Reference: Preliminary/Final Subdivision Plan - First Plan Review
800 W Bridge Street
Tax Map Parcel Number: 15-12-234

As requested, Gilmore & Associates, Inc. has reviewed the Preliminary/Final Subdivision plan for 800 W Bridge Street, dated September 22, 2025, prepared by Herbert E. MacCombie, Jr., P.E. Consulting Engineers and Surveyors, Inc., for the applicant 800 W. Bridge LLC.

ChescoViews Parcel Lot Lines for TMP No. 15-12-234, compared to the lot lines indicated on the plan submission, dated 9-22-2025.

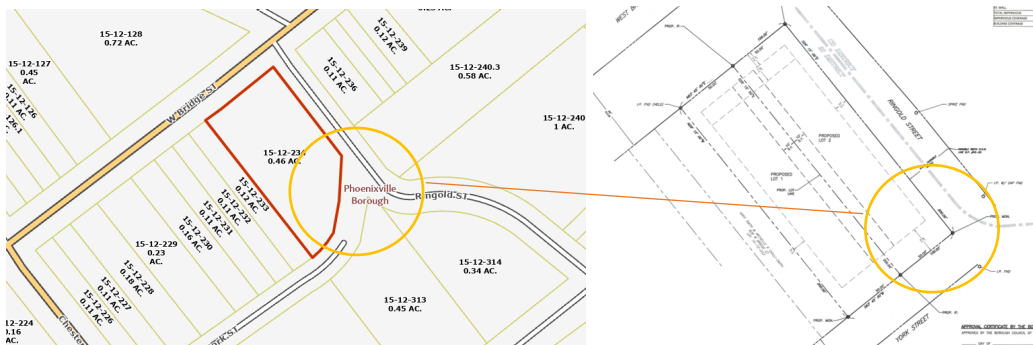
- d. The lot lines, as shown on the plan submission, do not align with the lot lines indicated on ChescoViews, and on the Zoning Map. Additional information should be provided regarding the existing property line.
